ADDENDUM A Staff Report: Z-30-21-2

North Gateway Village Planning

Proposed Use PCD removal to allow multifamily residential

CWS CAPITAL PARTNERS, LLC **BRONCO BUTTE MULTIFAMILY**

Revised Conceptual Site Plan, date stamped May 21, 2021

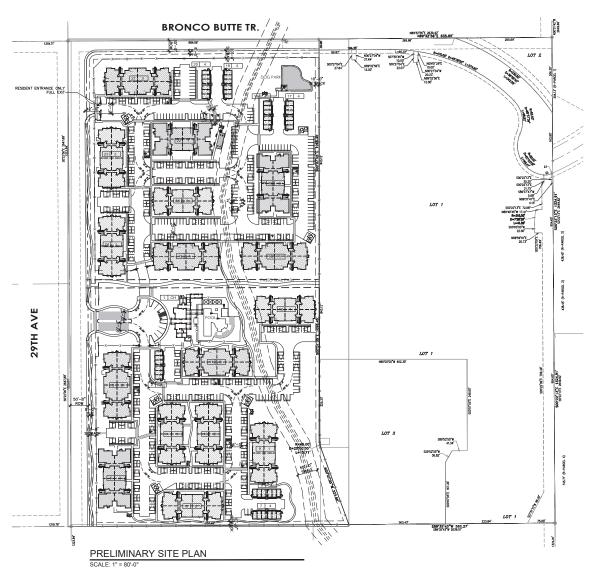
The purpose of this addendum is to revise a typographical error in the open space percentage on the site plan submitted with the case and subsequently included in the staff report. The original site plan included an incorrect open space calculation of 46 percent of the site. The applicant has since provided an updated site plan reflecting a corrected open space percentage of 16 percent. The remainder of the site plan information remains consistent with the originally submitted version.

PROVIDED: LOT COVERAGE: 185 015 / 827 012 = 22% OPEN SPACE: 151,764 / 910,592 = 16.66%
